# Service Bulletin

SB 1394T100-()RB-01

1394T100-()RB Turn Coordinator

**SUBJECT:** PCB Assembly Redesign

Figure 1 9016499-() Main PCB Assembly

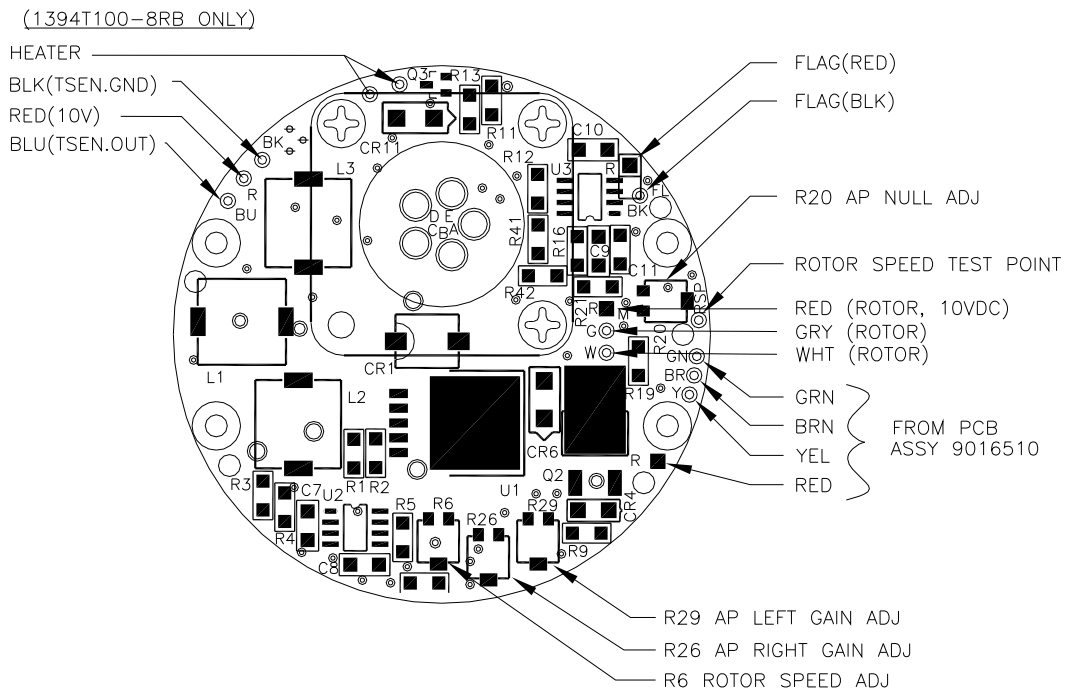
- E. Reattach the three wires from the Rotor PCB Assy. by looping the wires through the hole in the PCB Main and soldering them to the backside of the board in the locations shown in figure 1.

- F. Solder four wires (red, yellow, brown, and green) to the 9016510 PCB Assy. in the locations shown in figure 2. Solder the other end of these wires to the 9016499-() PCB Main Assy. in the locations shown in figure 1.

- G. Secure these wires using a cable tie to the upper standoff.
- H. Solder the red and black flag wires to the Main PCB at the locations shown in figure 1. Attach these wires to one of the lower standoff using cable ties.

- I. **\*\*\*For 1394T100-8RB Only:** Solder the red and black flag wires and the two orange heater wires to the Main PCB Assy. at the locations shown in figure 1. Attach these wires to one of the lower standoffs using cable ties. Solder the black, blue, and red wires from the heater regulator to the Main PCB Assy. at the locations shown in figure 1. Attach these wires to the other lower standoff using cable ties.
